DART+ WEST, ORAL HEARING SUBMISSION

SEPTEMBER 2023

ASHTOWN ROAD UPGRADE & ENTRANCE TO ASHTON HOUSE
FOR CASTLETHORN CONSTRUCTION

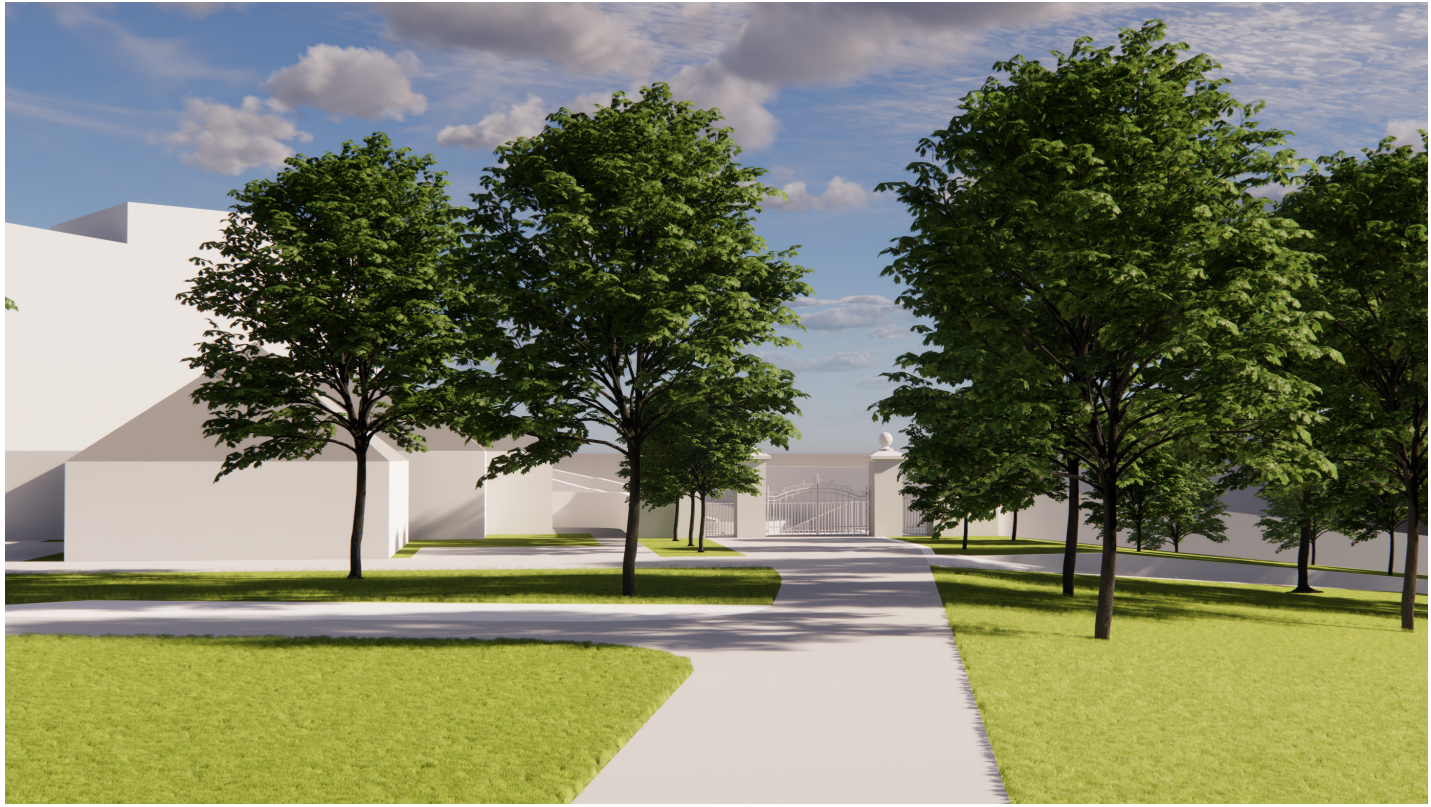
3d view of Ashton House entrance from Ashtown Road (Iarnrod Eireann Proposal)
As the level of the Ashtown Road Upgrade, where it meets the existing entrance area, is c. 2.7 metres below existing levels, the Iarnrod Eireann proposal includes a new access road within the grounds of Ashton House, which is a ramped road of c. 45 metres in length, at a gradient of c. 1:20. The proposed new access road will require retaining walls to both sides. The visual impact of the new access road is shown in the above image - the new access road effectively divorces the gate lodge from the entrance sequence, as it is positioned at a different level, and will be visually separated by the access road and its surrounding retaining walls and fence.

We accept that the level change of c. 2.7 metres in the vicinity of the entrance to Ashton House is inevitable. However, we maintain that this level change, and the proximity of the entrance area to the Ashtown Road Underpass render the existing access point unsuitable as a vehicular access point, and that the existing entrance should become pedestrian and cycle only, with vehicular access to Ashton House to be provided further north along the Ashtown Road, and at grade.

3d view of Ashton House entrance from Ashtown Road (Castlethorn Proposal)
In the Castlethorn proposal, the stone piers and gates are repositioned at the same level as their existing level, which maintains a harmonious relationship between the gate lodge and the piers, all of which are Protected Structures, and are intended to be seen together.
The proposed steps, located outside the repositioned gates, are not visible in this view, and the proposed ramp, located on the right hand side of the image, is very discreet, as it is combined with a generous area of planting.

Castlethorn Proposal, with proposed new 4-way junction in lieu of existing Ashtown Road roundabout.

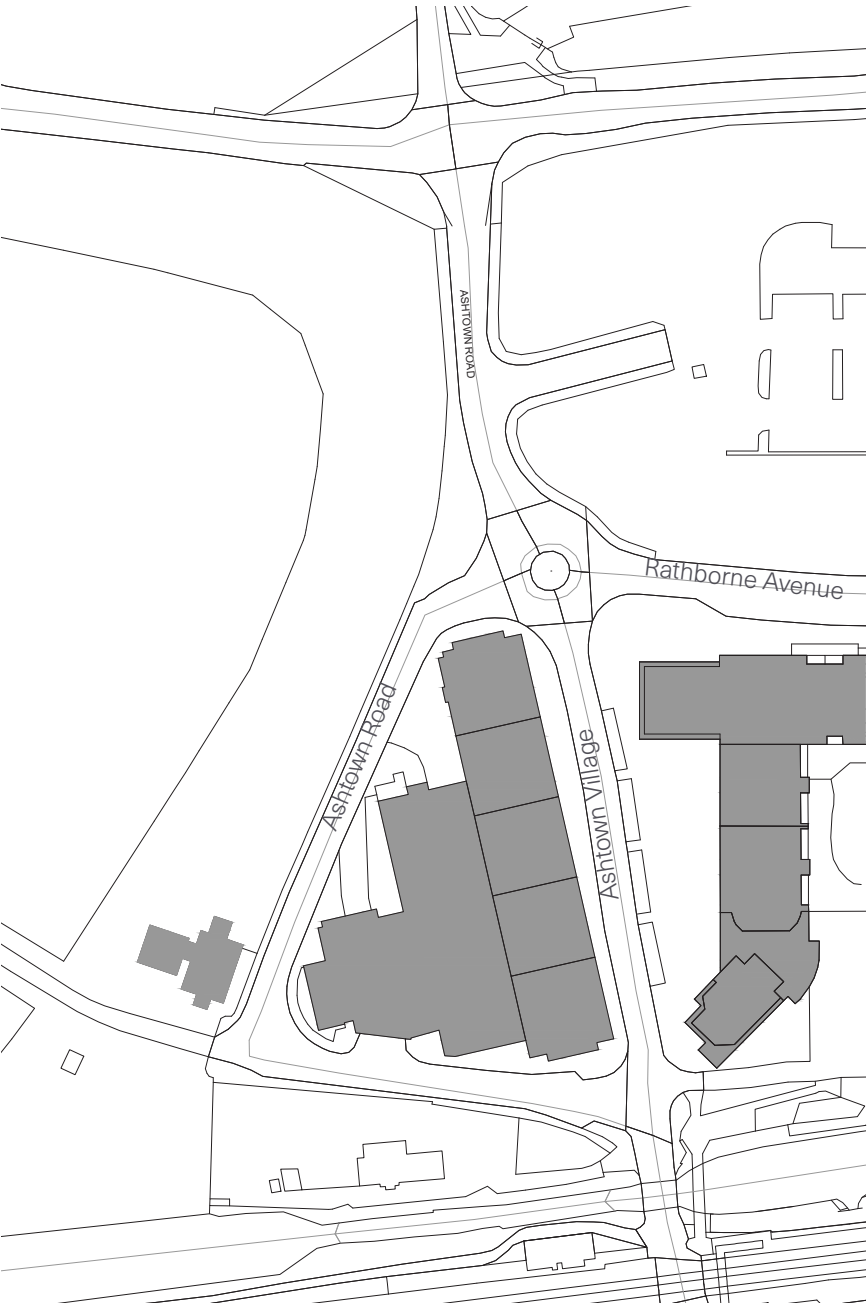
At the moment, the junction between the Ashtown Road, Rathborne Avenue and Rathborne Village is a roundabout. The Ashtown Road Upgrade proposes to maintain this roundabout, as shown in the middle image above. However, the road hierarchy between Ashtown Road, Rathborne Avenue and Rathborne Village will be changed by the Ashtown Road Upgrade, with the Ashtown Road Upgrade becoming a more important route, and Ashtown Village becoming a vehicular cul-de-sac.

The Castlethorn scheme proposes that the existing roundabout be replaced by a 4-way junction, between the Ashtown Road Upgrade, Rathborne Avenue and the proposed new vehicular access to Ashton House. The proposed new vehicular access to Ashton House is located where the Ashtown Road Upgrade is at existing levels, thereby avoiding any requirement for vehicular ramped access and retaining structures within the Ashton House lands. The proposed access point is c. 130 metres from the underpass that is part of the Ashtown Road Upgrade, is at grade and at an existing junction, which is a much more efficient, safe and logical location for a vehicular entrance that would maintain a successful relationship between Ashton house and Rathborne Village.
